## FERGUSON TOWNSHIP PLANNING COMMISSION REGULAR MEETING AGENDA

SUBJECT: Orchard Square Preliminary Land Development Plan

- TO:** Kristina Bassett, Community Planner
- FROM:** Jeffrey Ressler, Zoning Administrator *JR*
- DATE:** October 7, 2021
- SUBJECT: Orchard Square Land Development Plan 2<sup>nd</sup> Review**

TO: Kristina Aneckstein, Community Planner  
FROM: Ron Seybert, Township Engineer  
DATE: October 5, 2021   
SUBJECT: Orchard Square Preliminary Land Development Plan  
Third Review (ES – 426)

### RECORD PLAN

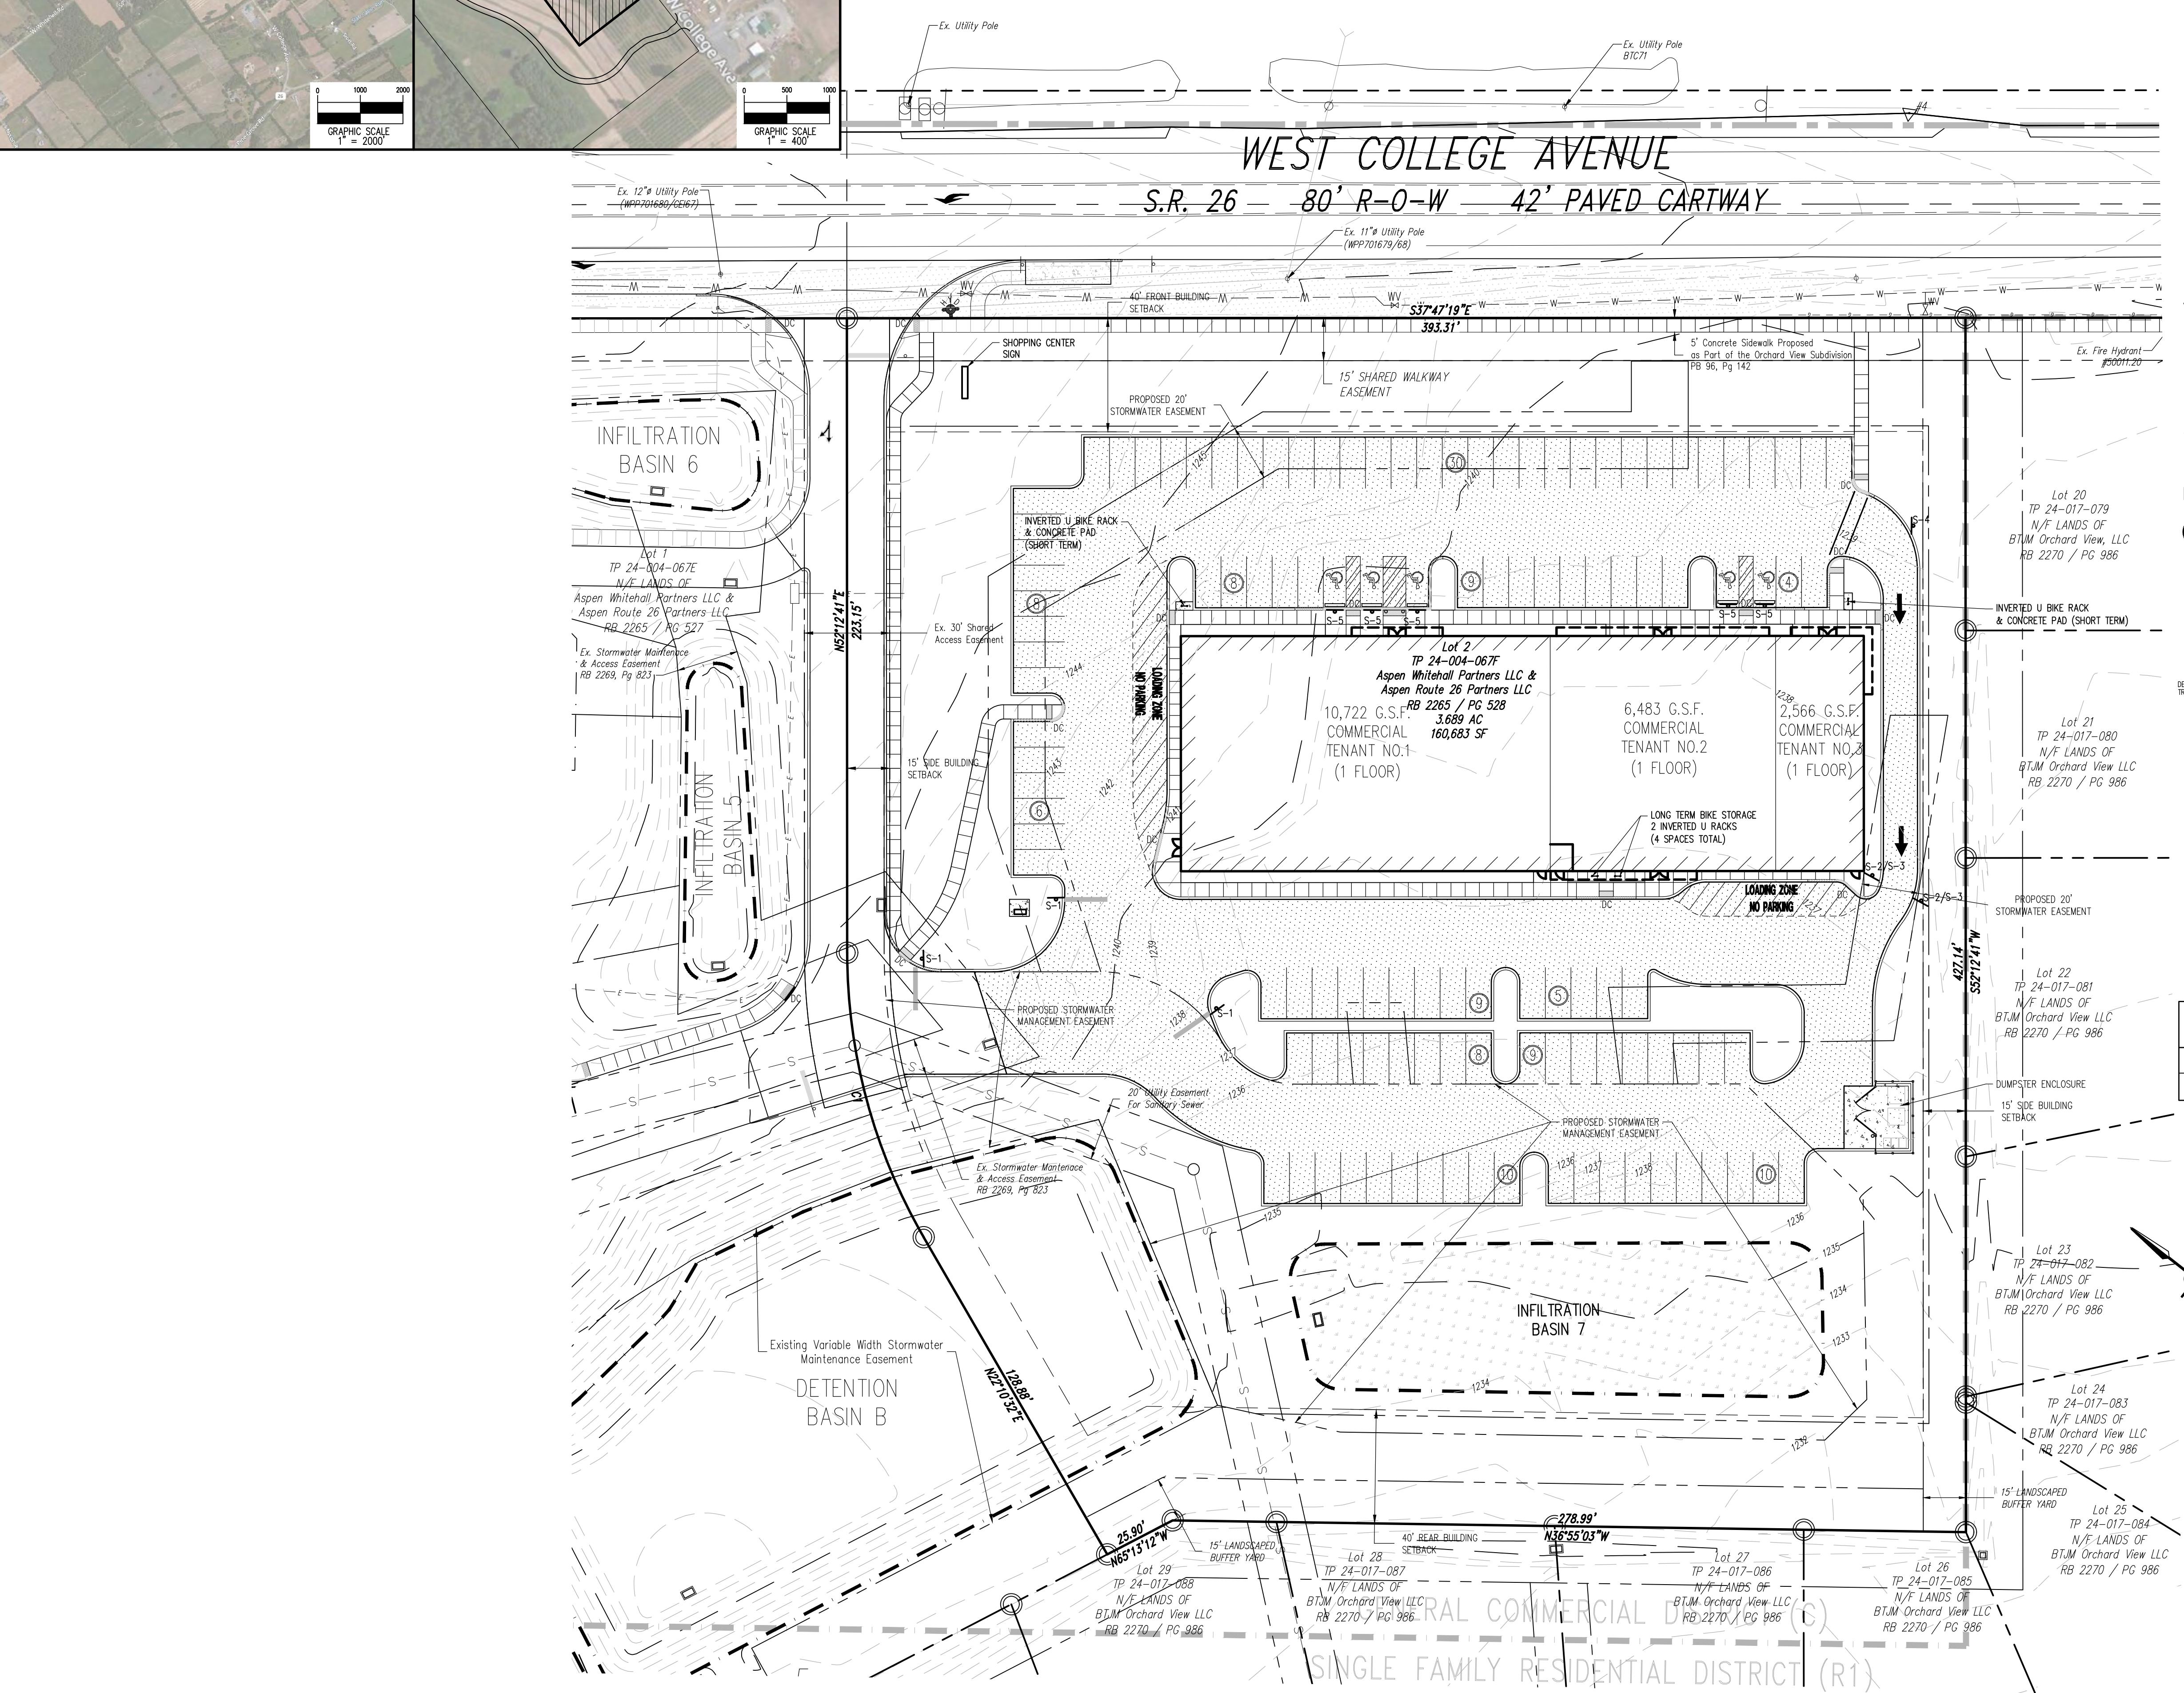
10. The property is located in the Source Water Protection Overlay District Zone II. Note number 2a on the plan should be revised to add that this property is in the Source Water Protection Overlay District Zone II. **Comment Addressed.**
